Ducted Systems Technical Services Service Letter

Letter: **YS-001-2020**

Subject: **Blower motor location in belly-band – Regal Beloit Ensite® Blower Motors**

Product: **TM8X, TMLX, TM9X, TM9E, TM9Y, RGF19*E, RGF29*E, RGF1L*E, RGF2L*E, MM9E**

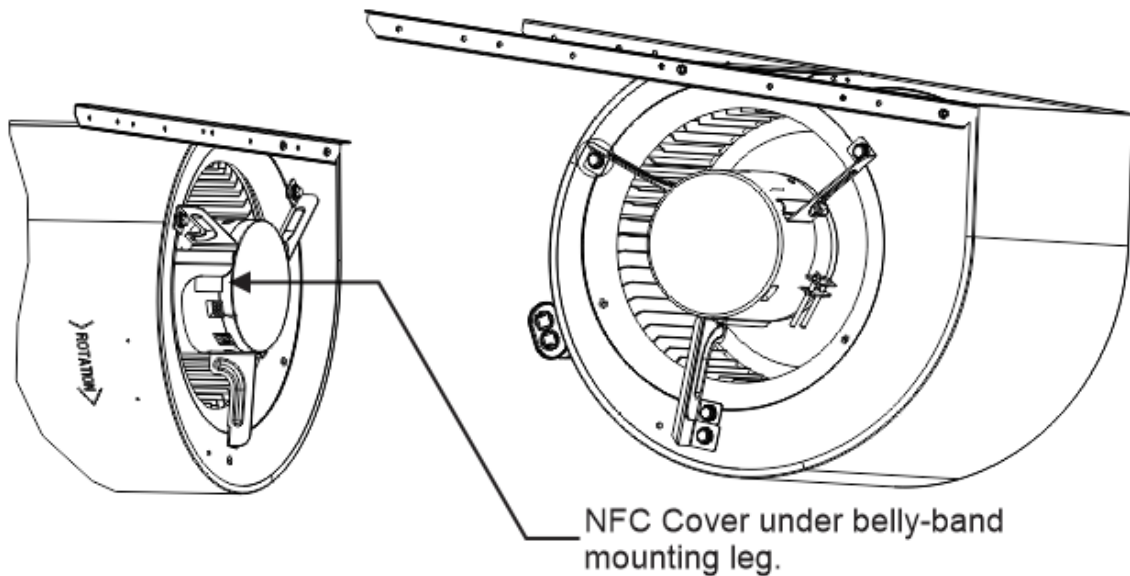
Another reason we found causing excessive blower motor noise is related to some of the motors not being installed correctly in their belly-band mounting assembly during furnace production. The Ensite® motor has a white plastic cover over the NFC programming sensor as shown in the image above. In some cases, the motor belly-band must be relocated/repositioned on the motor. Shown below is an assembly drawing of the motor, belly-band and blower assembly. Notice that the NFC cover is under one of the belly-band mounting legs. When the belly-band is in this position, the motor is not square with the blower assembly and this can lead to excessive noise.

NFC Cover and electrical connections between belly-band clamp area.

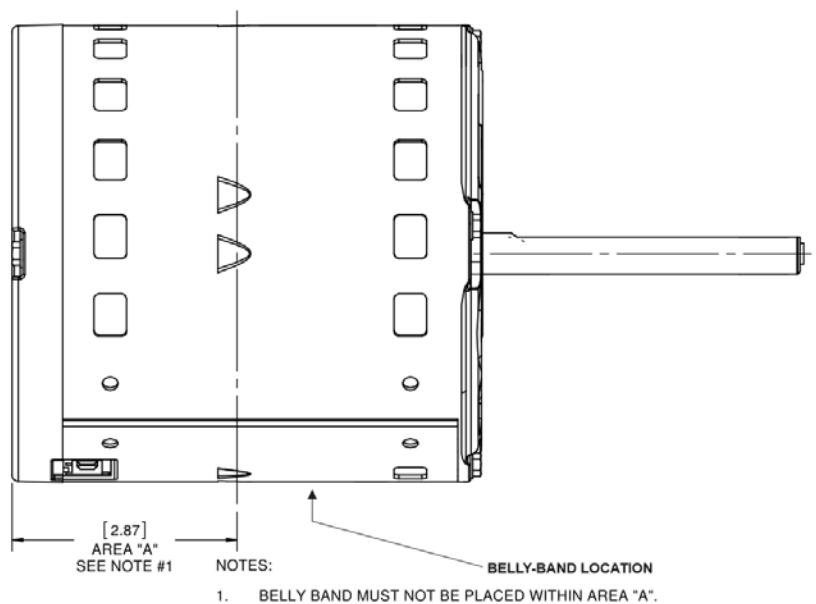
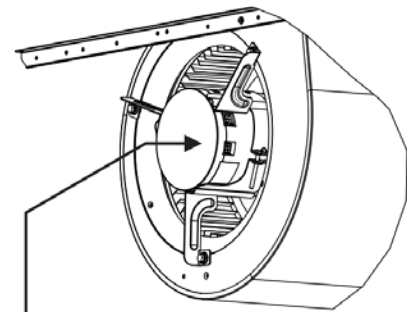
For ½ and ¾ horsepower motors, the belly-band **is** in the correct location in relationship to the end of the motor (location shown in the image to the right) but the motor must be rotated so that the NFC and electrical connections are in the area where the belly-band clamp bolts are located. Shown below is an assembly drawing of the blower assembly showing the blower motor NFC cover and electrical connections after the motor has been rotated in the belly-band. Notice the connections are in the section of the belly-band where the clamp bolts are located.

NOTES:
 1. BELLY BAND MUST BE PLACED WITHIN AREA "A".

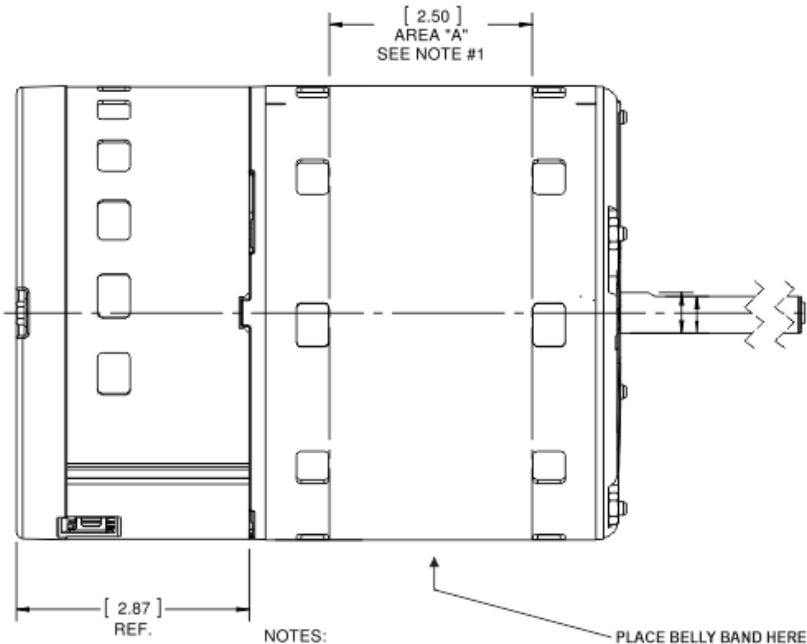
For 1 horsepower motors, the belly band needs to be adjusted so that it is within the appropriate area on the motor. The belly-band must be adjusted toward the shaft end of the motor. Reference the image below showing the correct location of the motor belly-band. The belly-band must be moved into area “A” as shown below.
